DEVELOPMENT APPLICATION ASSESSMENT REPORT

Application Number:	DA2021/1805
----------------------------	-------------

Responsible Officer:	Adam Mitchell
Land to be developed (Address):	Lot A DP 379308, 4 Alexander Street COLLAROY NSW 2097
Proposed Development:	Demolition works and construction of a seniors housing development
Zoning:	Warringah LEP2011 - Land zoned R2 Low Density Residential
Development Permissible:	Yes, under State Environmental Planning Policy (Housing for Seniors or People with a Disability) 2004
Existing Use Rights:	No
Consent Authority:	Northern Beaches Council
Delegation Level:	NBLPP
Land and Environment Court Action:	Yes
Owner:	East Coast Property Development Pty Limited
Applicant:	East Coast Property Development Pty Limited

Figure 1 - Plan extract showing the 3 storey building height as viewed from the east

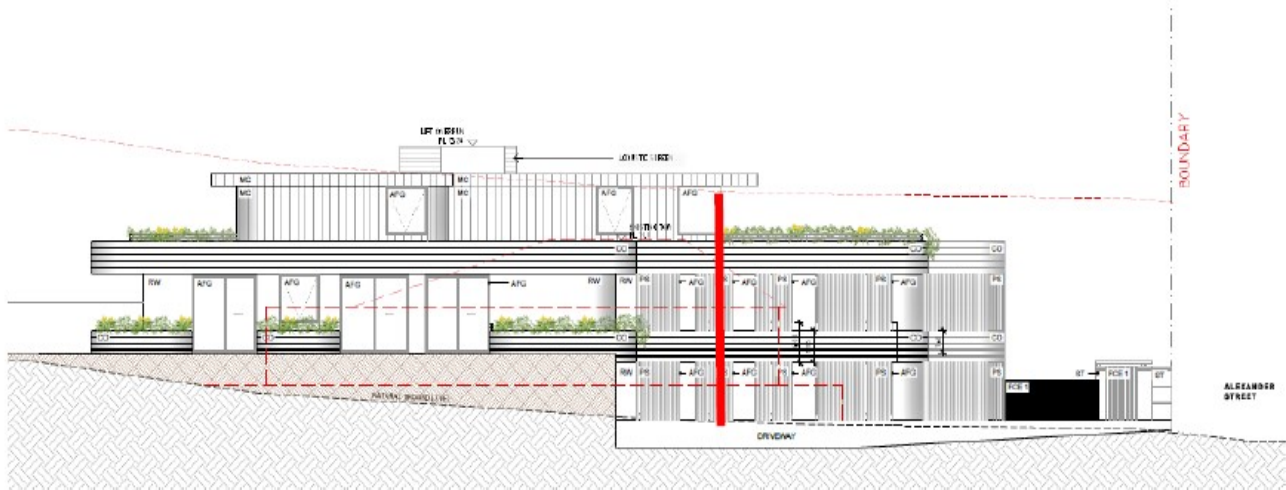
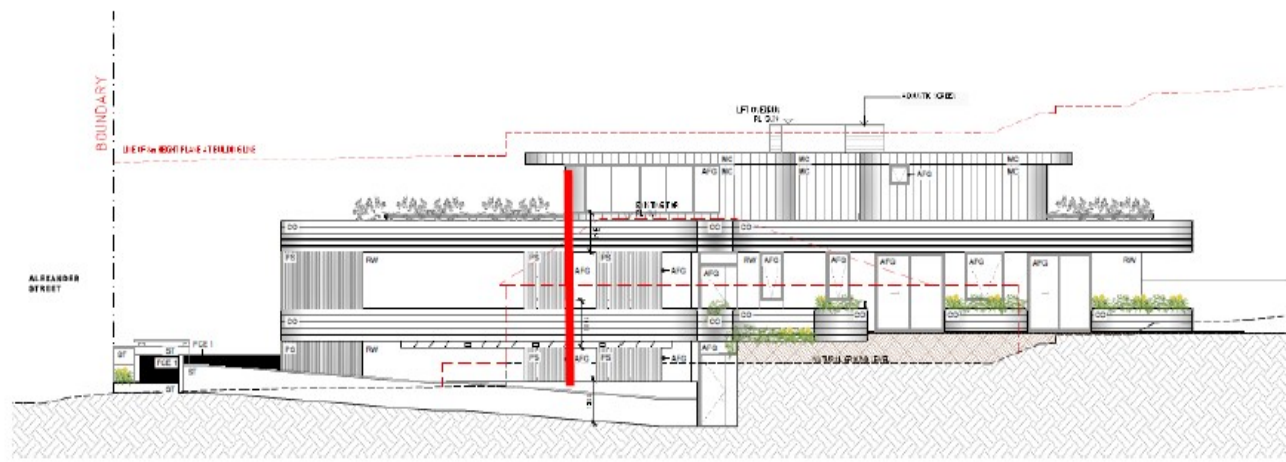
Below are two figures taken from the applicant's Clause 4.6 variation request which show (with red bolded line) the portion of buildings adjacent to a boundary that are more than two storeys in height:

The topmost floor of the proposed development is the offending portion of the building with respect to cl.40(4)(b). That floor is stepped in from the outer edges of the floor below and finished with a different facade material to visually break up the building. The extent of areas where the building is perceived as three (3) storeys when adjacent to a boundary is relatively minor compared to the totality of the building. It is concurred with that there is no meaningful planning reason to ensure compliance with the control is maintained as the building is well designed and set off the boundaries significantly greater than what is required.

The building does not appear to have an abrupt change in height. The change in height is negotiated

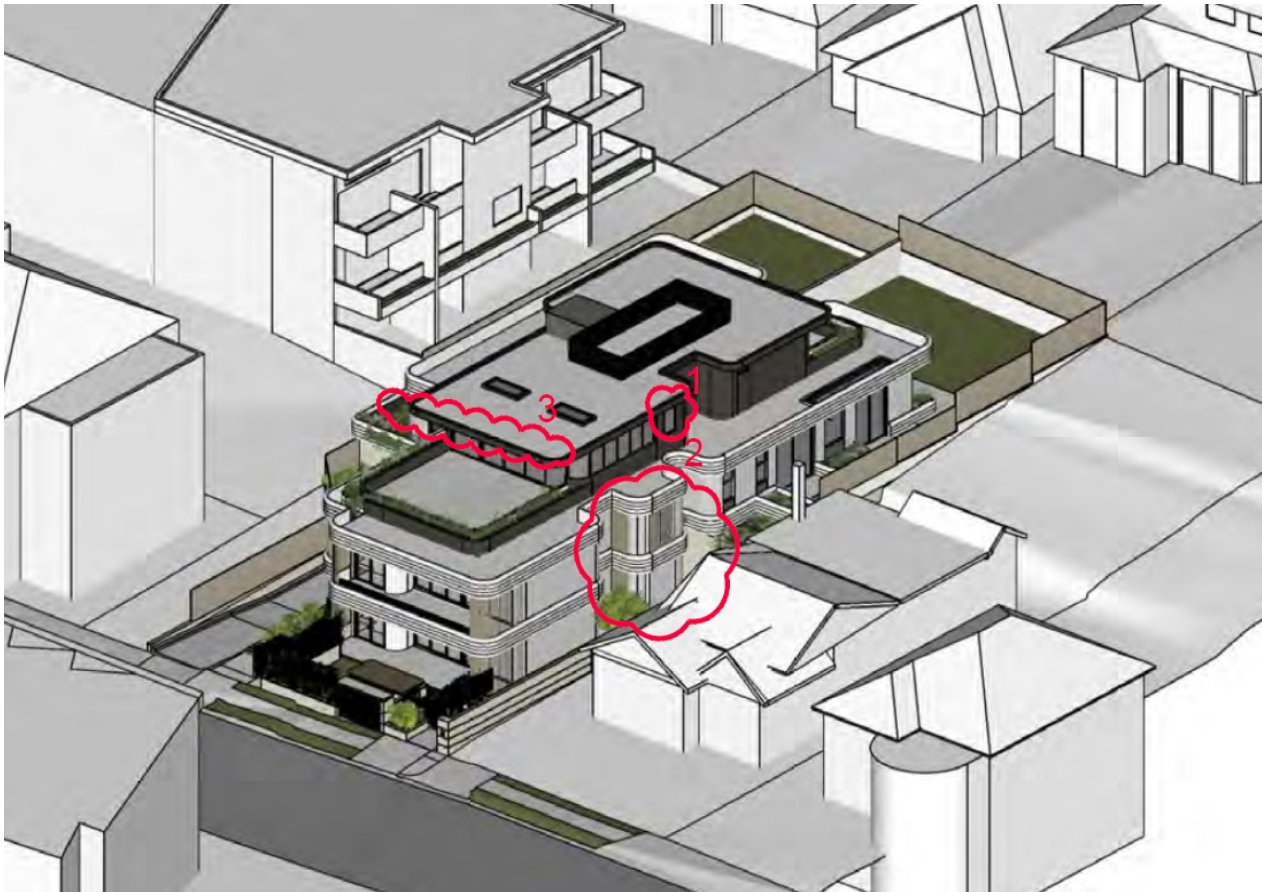
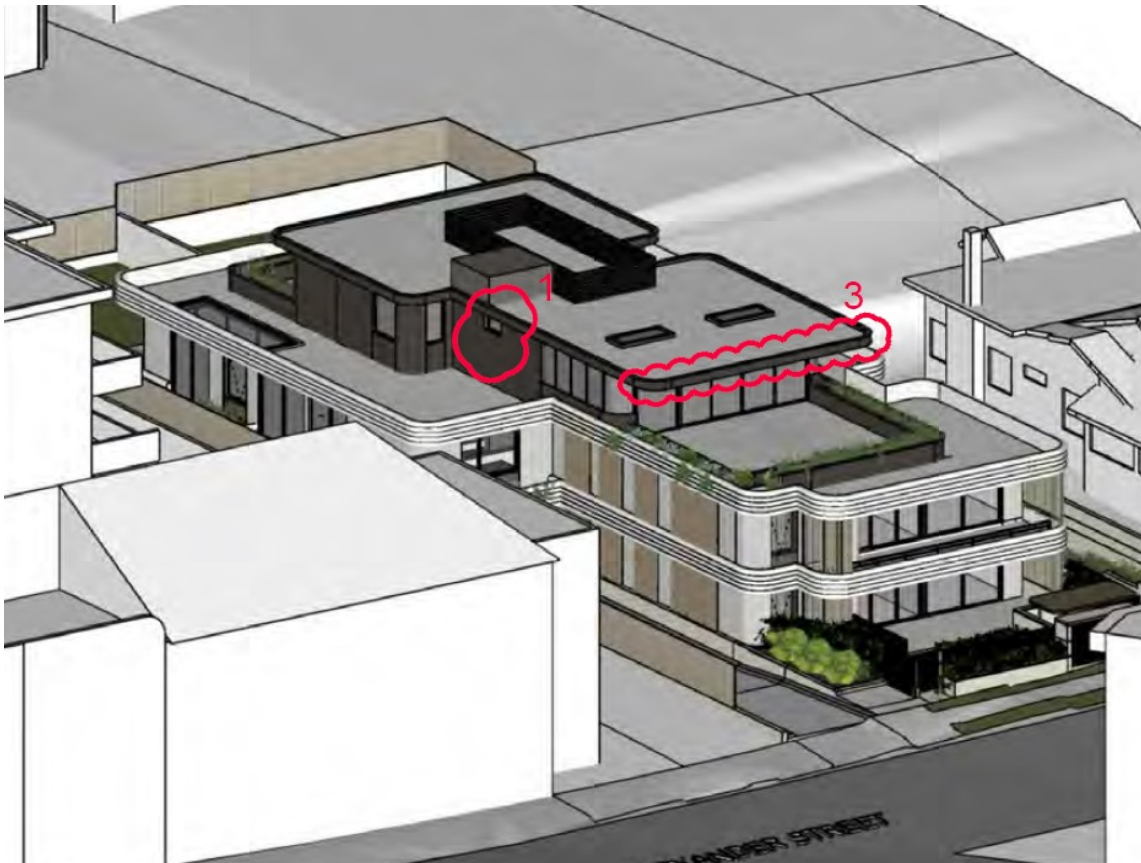
The applicants written request argues, in part:

- that the objectives and purposes of the standard are achieved.
- that the underlying purpose of the standard is not relevant to the development.
- that the proposal complies with the setback controls under the WDCP 2011.
- that the building height (except for the liftshaft) complies with the WLEP 2011.
- that the WDCP 2011 does not contain a storey limit control. A three storey dwelling could be constructed on the site.
- that the non-compliance is not directly attributable to any impacts on adjacent land.

Therefore, the applicant's written request has adequately demonstrated that there are sufficient environmental planning grounds to justify contravening the development standard as required by cl 4.6 (3)(b).
